DEVELOPMENT REVIEW BOARD REPORT

CASE NUMBER/ PROJECT NAME	34-DR-2006 Paseo Village Remodel		
LOCATION	E. McCormick Parkway at E. Via Del Paseo Del Norte		
REQUEST	Request approval of a site plan, landscape plan, and elevations to modify an existing commercial center.		
OWNER	Deercrest 13 LLC	ENGINEER	N/A
ARCHITECT/ DESIGNER	Architecture 3 LLC 602-346-5026	APPLICANT/ COORDINATOR	Gary Striyle Architecture 3 LLC 602-346-5026

1 PRELIMINARY SITE PLAN

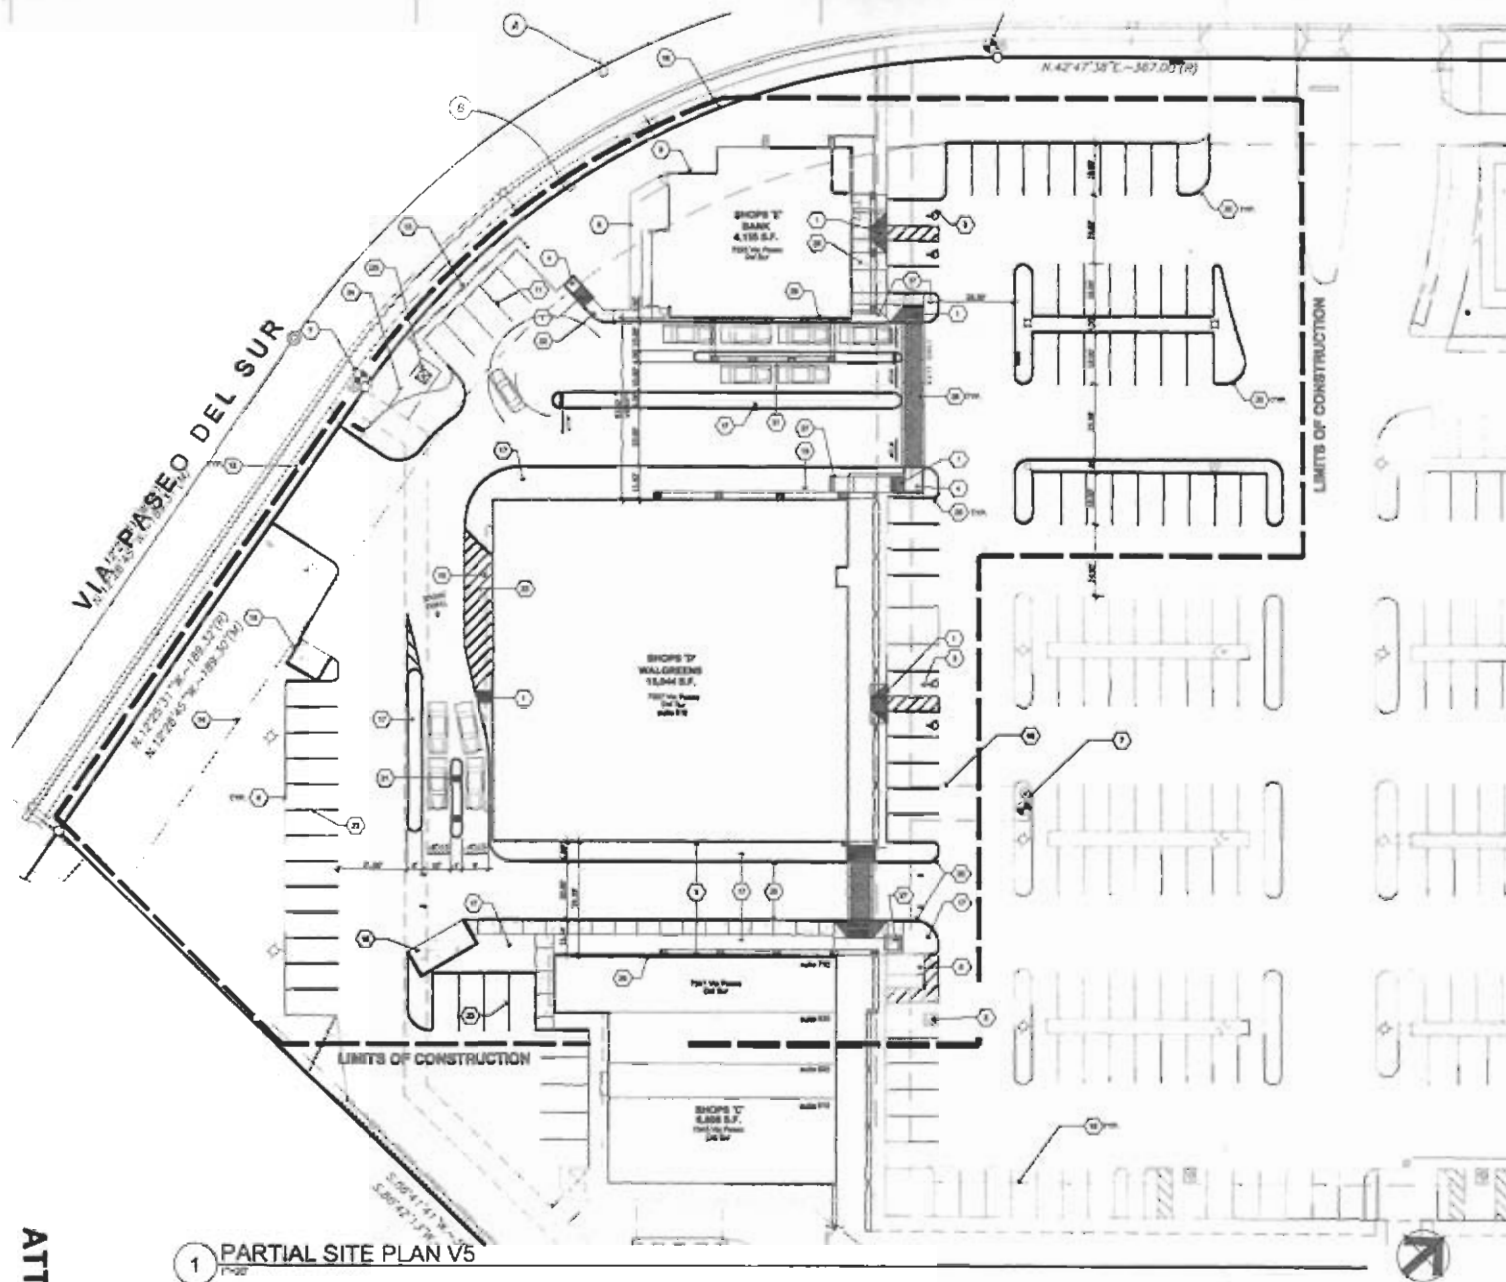
The new drives will be 20 feet in width and have been approved by the City's Transportation and Fire departments. Responding to staff's comments, the applicant has revised the parking lot in front of the bank by aligning the drive aisle with the new proposed lane. The intent of modifying the parking lot is to safely direct vehicular traffic through this area of the site. In addition, landscape islands extend along the bank ATM drive to assist in directing vehicular traffic around the new proposed drives.

The proposal will affect the existing commercial center's in-line shops. No new buildings are proposed. Existing tenant space will be reduced by 8,005 square feet to allow for the new drive lanes. The parking lot will be modified to direct vehicular traffic through the site. New landscaping will be added around the new drives. Additionally, turf area will be removed and new desert landscaping will be incorporated between the parking lot and street frontage along E. Via Paseo Del Sur.

22. The developer shall provide a minimum parking-aisle width of 24 feet, except the 20 foot wide drive aisles near the buildings per the approved DRB site plan are acceptable.
23. The developer shall provide internal circulation that accommodates emergency and service vehicles with an outside turning radius of 45 feet and inside turning radius of 25 feet.
24. The developer shall provide a minimum of 120 feet of queuing distance for all "drive-thrus" (Bank, fast-food, etc.).
